Landscape Review Committee
Community Development Center, 231 NE 5th Street
ZOOM Online Meeting:

May 20, 2020 - 12:00 PM

DATE: May 20, 2020
TO: Landscape Review Committee Members
FROM: Jamie Fleckenstein, Associate Planner
SUBJECT: Agenda Item 4A – Landscape Plan Review Application (L 5-20)

An application for a landscape plan review (L 5-20) for landscaping for the development of Granary Row, a modern communal space for four (4) micro-restaurants in the Northeast Gateway District to be reviewed by the Landscape Review Committee.

Figure 4: Proposed Landscape Plan**Attachments:**

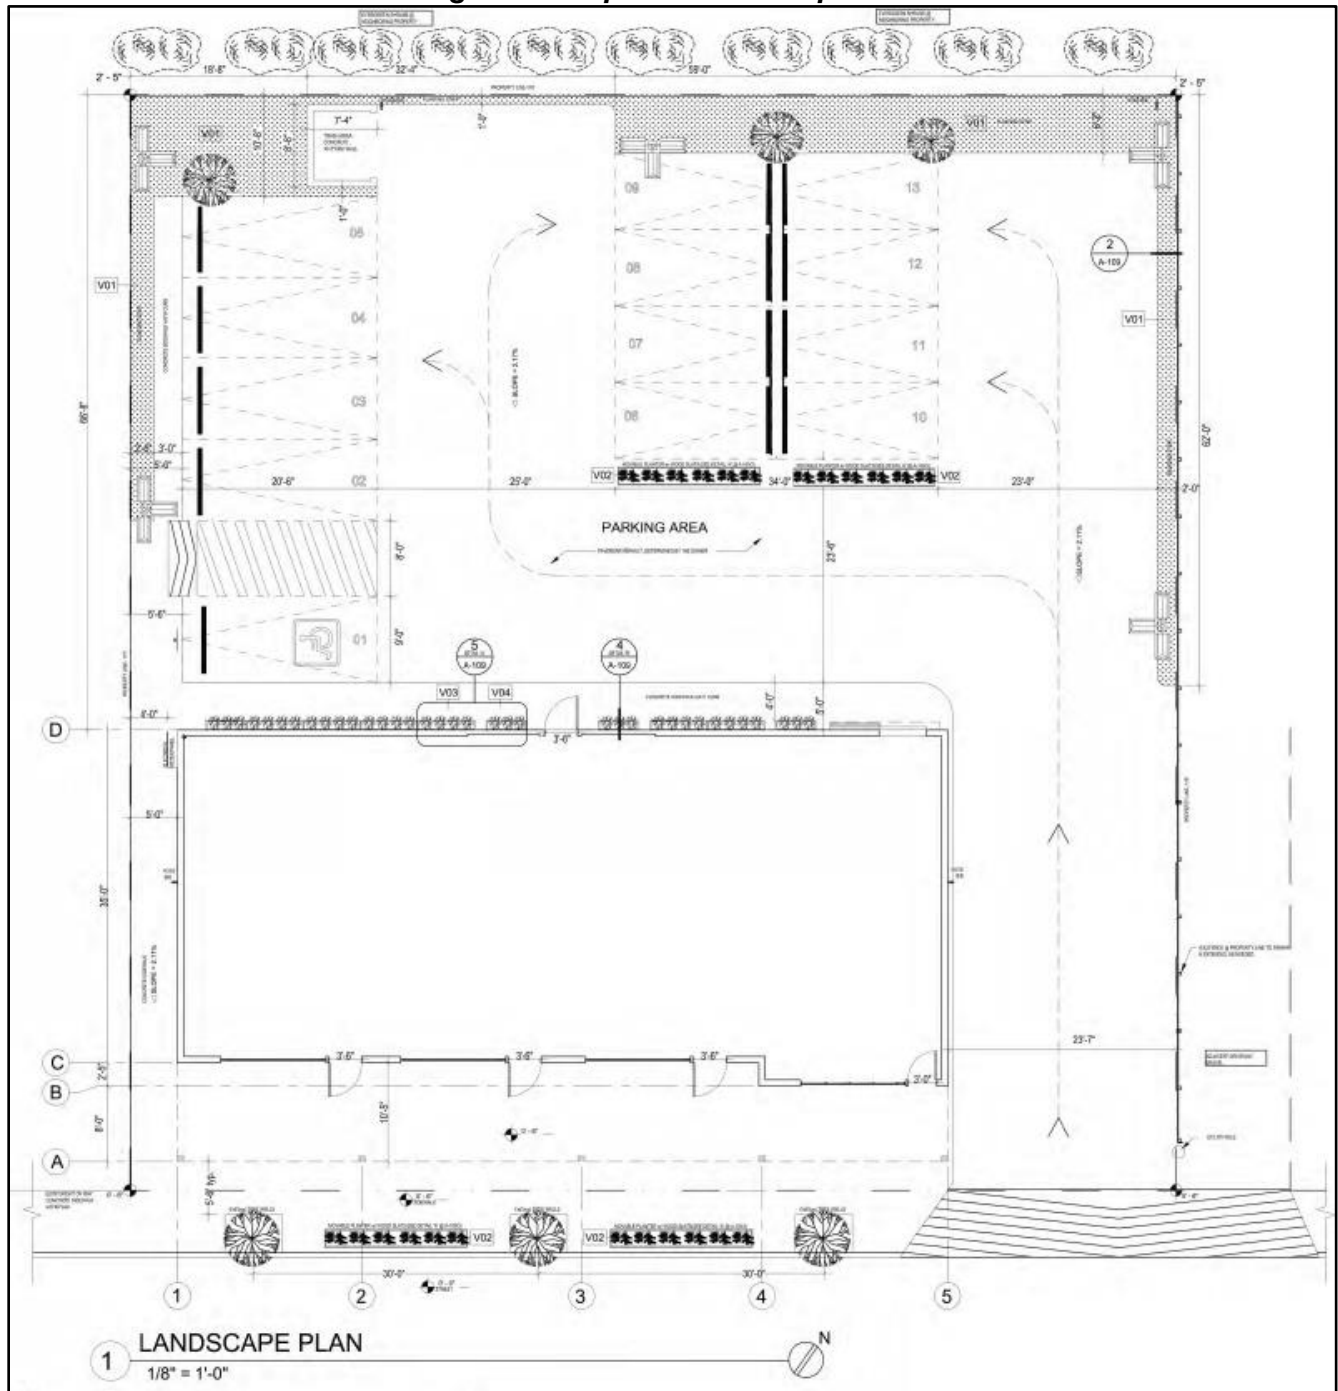
Issue	Notes	Condition to Help Meet Criteria
Compatibility with the project and surrounding properties and uses	<ul style="list-style-type: none"> Landscaping supports project goals and vision of NE Gateway District Planters not compatible with location next to Lafayette Avenue No landscaping along rear property line 	<p>Condition #2: Northern street tree removed to maintain vision clearance</p> <p>Condition #3: Moves planters to the back edge of sidewalk away from Lafayette Ave.</p> <p>Condition #4: Requires privacy fence along rear property line</p>
Screening the proposed use	<ul style="list-style-type: none"> Parking lot is screened from residential uses by existing fences, no screening along rear property line Trees will buffer and screen building and parking lot Landscaping not required around trash enclosure – not visible from ROW 	Condition #4: Requires privacy fence along rear property line

Retention of existing trees	<ul style="list-style-type: none"> Small existing tree proposed for removal to accommodate required maximum setback from front property line 	N/A
Parking lot islands and planting	<ul style="list-style-type: none"> Movable planters proposed within parking lot interior Planter/Planting may obstruct vision in parking area Trees planted along north property line along perimeter of parking area 	Condition #5: Limits height of planter/planting to 3½'
Use of suitable street trees	<ul style="list-style-type: none"> Overhead power line and adjacency to arterial street require select characteristics in a street tree along Lafayette 	Condition #9: Requires a tree less than 25' tall with a narrow, upright, or columnar form

1. That the applicant shall revise the landscape plan submitted to the Planning Department on March 24, 2020 to comply with required conditions of approval, and shall submit the final revised landscape plan to the McMinnville Planning Department for verification of compliance and administrative approval.
2. That no street tree shall be located closer than approximately 40 feet to the southern edge of the driveway access.

3. That planters along Lafayette Avenue shall be located closer to the building such that there is a minimum clear distance between the planter and the back edge of street tree planting wells to allow an accessible path of travel along the public sidewalk adjacent to the site.

5. That the combined height of a planter box and mature vegetation within the interior of the parking lot shall not exceed three and one-half (3.5) feet.

6. That the combined height of a planter box and mature vegetation between the sidewalk and the front building line shall not exceed three (3) feet.
7. That if the NE Gateway Waiver for Section 10(C) is not approved during the Northeast Gateway Design Review process (docket NEG 1-20), the parking lot landscaping shall be redesigned to comply with applicable standards and criteria, and resubmitted to the McMinnville Landscape Review Committee for review and approval.

Figure 4: Proposed Landscape Plan

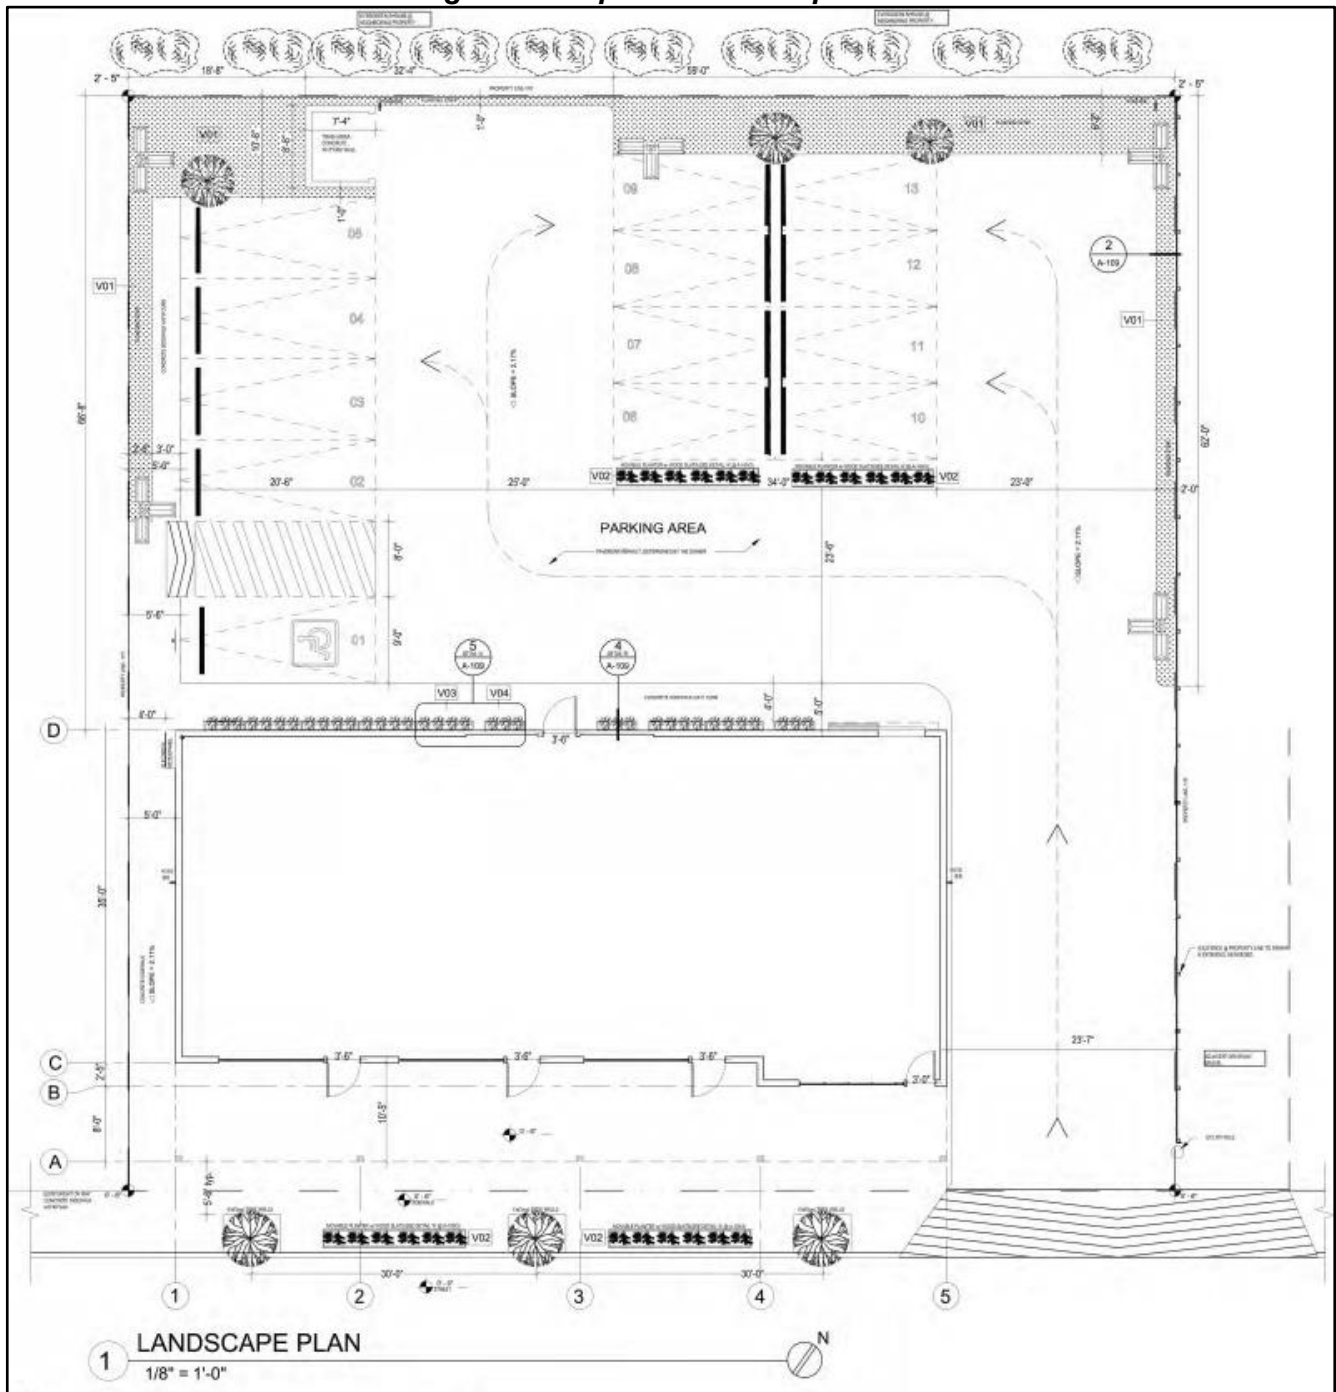
1. That the applicant shall revise the landscape plan submitted to the Planning Department on March 24, 2020 to comply with required conditions of approval, and shall submit the final revised landscape plan to the McMinnville Planning Department for verification of compliance and administrative approval.
2. That no street tree shall be located closer than approximately 40 feet to the southern edge of the driveway access.

3. That planters along Lafayette Avenue shall be located closer to the building such that there is a minimum clear distance between the planter and the back edge of street tree planting wells to allow an accessible path of travel along the public sidewalk adjacent to the site.

5. That the combined height of a planter box and mature vegetation within the interior of the parking lot shall not exceed three and one-half (3.5) feet.

6. That the combined height of a planter box and mature vegetation between the sidewalk and the front building line shall not exceed three (3) feet.
7. That if the NE Gateway Waiver for Section 10(C) is not approved during the Northeast Gateway Design Review process (docket NEG 1-20), the parking lot landscaping shall be redesigned to comply with applicable standards and criteria, and resubmitted to the McMinnville Landscape Review Committee for review and approval.

1. The submitted landscaping plan shows three trees along the frontage, and the narrative refers to Pacific dogwoods as a choice. The applicant should be reminded that street trees are the maintenance responsibility of the adjacent property owner.

- a. The location of the most northerly tree will be in the intersection sight distance triangle for vehicles turning left from the access, and should be removed from the plan. The trees to the south are not within that area.

2. The proposed moveable planter boxer along Lafayette Avenue are not preferred by Public Works. Given the adjacent bike lane, traffic volumes and speeds along Lafayette, we believe that these could pose a hazard if they were to find their way into the roadway. We would also be concerned about an errant vehicle colliding with these large planters. We would recommend not allowing these planters in the right of way.

Unable to approve landscaping plans at this time. Plans do not indicate existing water facilities. Future public water facilities are not know at this time or their locations.

Figure 6: Lafayette Avenue Landscaping**Figure 7: Planter Detail A**

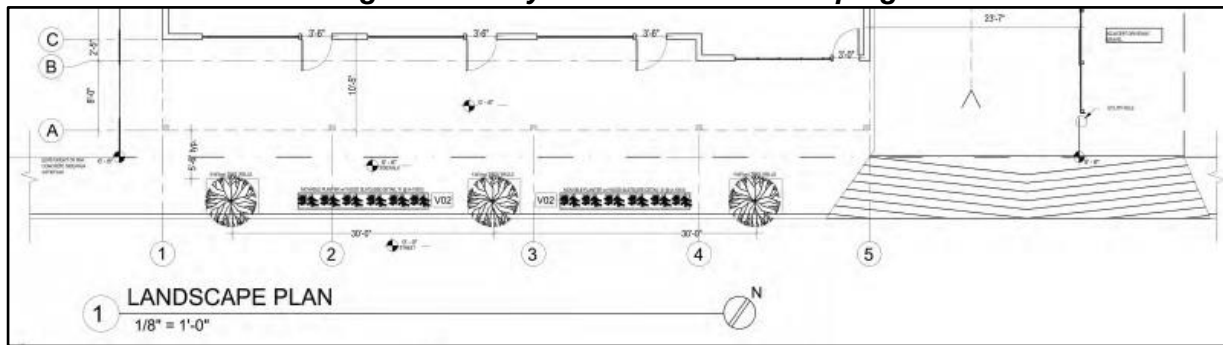
Landscaping in the front of the building along the Lafayette Avenue frontage is intended to maximize the outdoor dining while providing screening and buffering from traffic on Lafayette Avenue. **See Figure 6 (Lafayette Avenue Landscaping).** Proposed landscaping includes three (3) street trees in tree wells, and raised planters between the street trees planted with the ornamental grass *Panicum virgatum* (Switch Grass). The raised planters are described in the application as two (2) feet wide, approximately three (3) feet tall, and varying in length. They would be wrapped with wood trim. They are not intended to be permanently affixed, but rather movable with machinery such as a pallet jack. **See Figure 7 (Planter Detail A).** Switch Grass, the proposed plant material for the planters along Lafayette Avenue, is a grass that forms clumps two (2) to four (4) feet wide. When in bloom, the overall height of the foliage and flower stalks can reach four (4) to (7) feet. Switch Grass is persistent through the winter. Public Works staff review of the proposed landscape plan raised concern with the location of planters immediately adjacent to travel lanes of Lafayette Avenue and recommends moving the planters out of the sidewalk area to reduce the risk of vehicles striking a large object. Based on a study of vision clearance of north-bound traffic on Lafayette Avenue, staff also recommended removing the northernmost street tree to preserve clear vision of exiting the site. Therefore, a conditions are included that no street tree shall be located closer than approximately 40 feet to the southern edge of the driveway access, and that planters shall be located closer to the building such that there is a minimum clear distance between the planter and the back edge of street tree planting wells to allow an accessible path of travel along the public sidewalk adjacent to the site.

Figure 8: Outdoor Event Space/Parking Landscaping

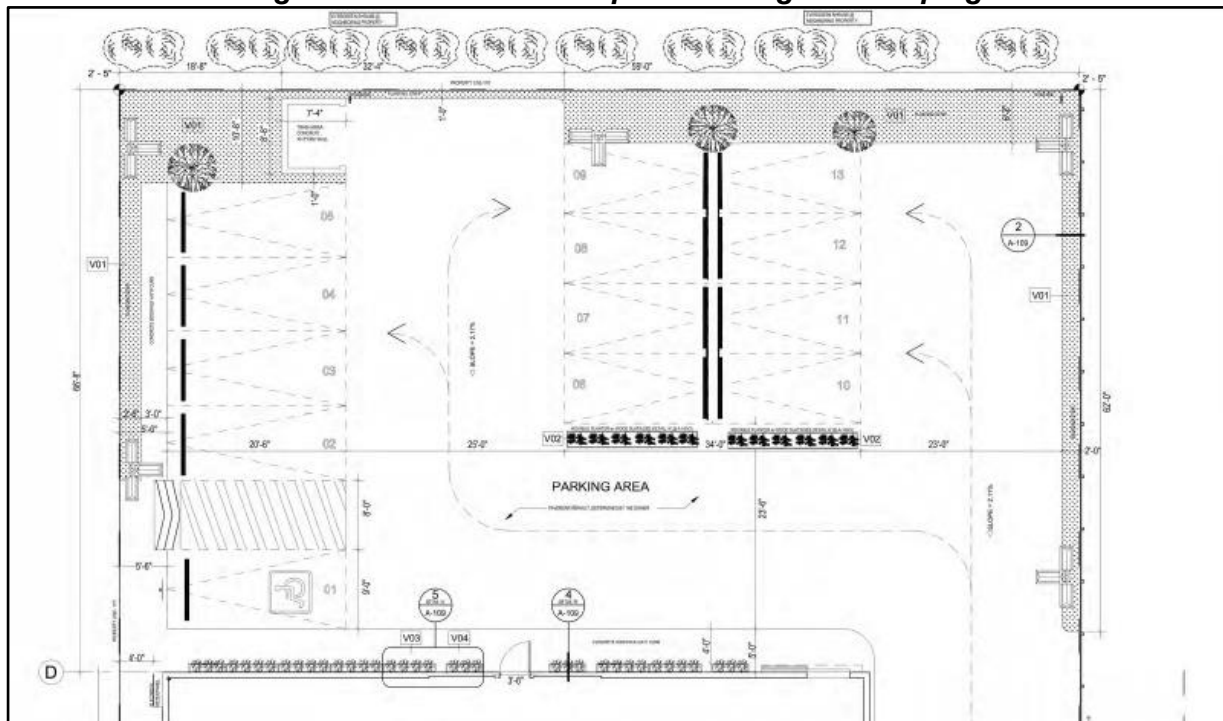
In the northwestern half of the site, landscaping is proposed around the perimeter of the off-street parking area/outdoor event space, and within the interior of the parking lot in planters. **See Figure 8 (Outdoor Event Space/Parking Landscaping).** The intention of the proposed planters within the parking lot is to locate them at the end of parking aisles to provide screening of the parking spaces, and have the flexibility to move them to accommodate outdoor events in the area. The applicant has indicated that the planters would be sufficiently heavy that it would take machinery such as a pallet jack to move the planters, and they would not be easily moved otherwise. The low speed of vehicles within the parking lot does not raise the same level of concern as planters along NE Lafayette Avenue, where a higher volume of traffic is moving at higher speeds. Switch Grass is the proposed plant for the parking lot planters. The combined height of the planter and grass (when in bloom) could exceed seven (7) feet.

Landscaping around the perimeter of the parking lot consists of perennial rye grass (lawn) and three (3) medium trees such as *Cornus nuttallii* (Pacific Dogwood). The Pacific Dogwood is a native tree that grows approximately 45 feet tall and 20 feet wide. The trees are located to provide canopy cover over the parking area that would typically be provided by trees in internal parking lot islands. Lawn is proposed to provide flexibility for outdoor events in the area. Existing fences along the northeast and southwest property lines would remain. Currently no fencing or landscaping that would provide screening of the parking area to the commercial business adjacent to the northwest is proposed. Full enclosure of the outdoor event space would contain events to the property and help prevent event spill-over onto adjacent properties. Therefore, to be compatible with the adjacent properties, a condition is included that a privacy fence shall be provided along the northwestern property line and connect to existing fences to enclose the outdoor event space. The fence shall be a minimum six (6) feet in height and shall be sight-obscuring.
